<b>Docket Number:</b>	16-BSTD-06
<b>Project Title:</b>	Updates to the 2019 Time Dependent Valuation of Energy
<b>TN #:</b>	212515
<b>Document Title:</b>	Sierra Club Comments on 2019 Draft TDV Updates
<b>Description:</b>	N/A
<b>Filer:</b>	System
<b>Organization:</b>	Sierra Club/Rachel Golden
<b>Submitter Role:</b>	Public
<b>Submission Date:</b>	7/29/2016 4:08:27 PM
<b>Docketed Date:</b>	7/29/2016

## **Sierra Club Comments on 2019 Draft TDV Updates**

**Subject:** Sierra Club Comments on the 2019 Title 24 Draft Time Dependent Valuation of Energy Updates (Docket #16-BSTD-06)

Figure 1: Lifecycle CO2 Emissions from Mixed-Fuel and All-Electric Water Heating (E3 2016).

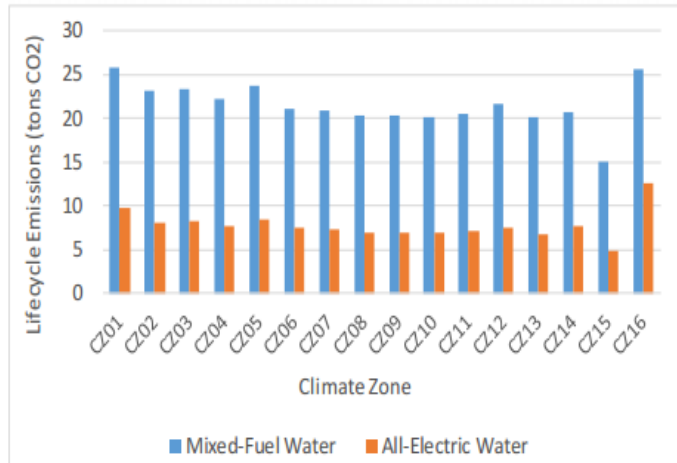
with gas space heaters typically produced roughly twice the lifecycle emissions of buildings with electric space heating. While buildings with gas space heating had lower lifecycle TDV values than electric space heating, the difference in most climate zones (except CZ 16) was negligible. These results were even more pronounced for water heating. Buildings with gas water heaters produced *more* than twice the emissions of buildings with electric water heaters (see Figure 1).

California would be misguided to allow such negligible differences in TDV consumption to be the sole determinant of fuel choices in new building construction and in renovations. It is critical that this is addressed in the 2019 code cycle so we can ensure that Title 24’s measure of cost effectiveness does not preclude climate- and environmentally-beneficial infrastructure investments.

**Recommendation:** The Commission should solicit and consider recommendations for how it can better align Title 24 and the Warren-Alquist Act’s cost effective energy savings mandate

with the broader state directive to support policies that will contribute to a 40 percent and 80 percent reduction in greenhouse gas emissions below 1990 levels by 2030 and 2050 respectively. We recognize that such an endeavor will require time and significant attention and may be beyond the scope or timeline of the 2019 code cycle. Therefore, in the interim, we urge the Commission to reconsider its use of gas as the baseline fuel for water heating in new construction and retrofits, and for space heating in retrofits. Specifically, we recommend the Commission establish a same fuel baseline for the TDV budget of a reference building and proposed design in the 2019 code cycle. For water heating, the baseline for buildings designed with electric water heating should be a minimum standard 55 gallon electric water heater. While changing the baseline fuel will not necessarily incentive construction of lower-emission buildings, it will at least remove a major barrier to the construction of low- or zero-emissions electric buildings.

Figure 2: Lifecycle TDV Consumption from Mixed-Fuel and All-Electric Water Heating (E3 2016)

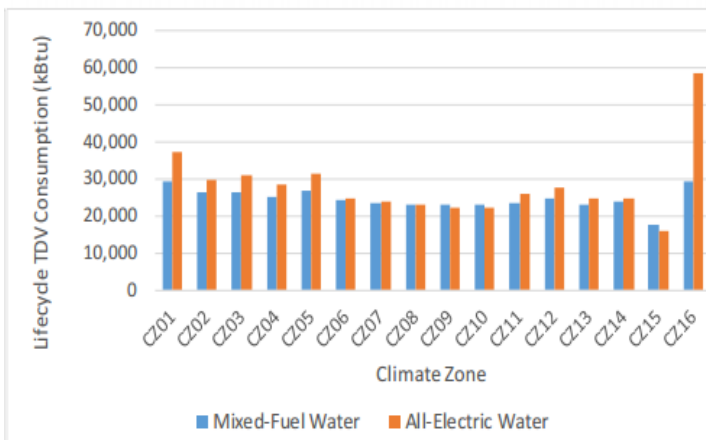
Again, while buildings with gas water heating had lower TDV consumption, the difference in most cases (except CZ 16) was marginal (see Figure 2).

Figure 3: CO2e Emissions Price Forecast from 2015 IEPR (E3 2016)

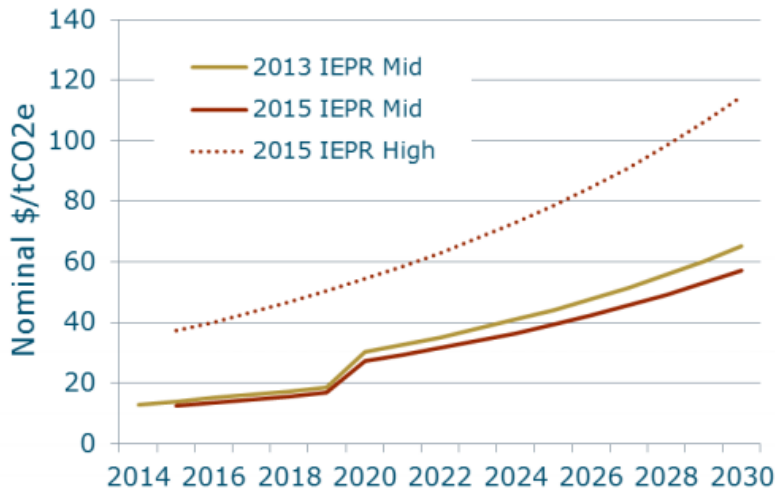
Moreover, the actual costs of greenhouse emissions embedded in the TDV values do not reflect the cost of greenhouse gas abatement needed to achieve the state's long-term climate goals. Currently, the proposed emissions price forecast for the 2019 code is from the 2015 IEPR for 2020-2030, and then extrapolated to 2049 using a linear trend (see Figure 3).

The emissions price forecast from the 2015 IEPR is too low and will not lead to responsible fuel choice decisions for the future building stock. These carbon prices do not reflect the cost of the infrastructure changes needed to meet California’s 2030 and 2050 climate goals.

We also recommend the Commission update its emissions price forecast to more accurately reflect the cost of achieving long term climate goals. The Commission should consider using a social cost of carbon as an input for the emissions cost in the TDV calculation.
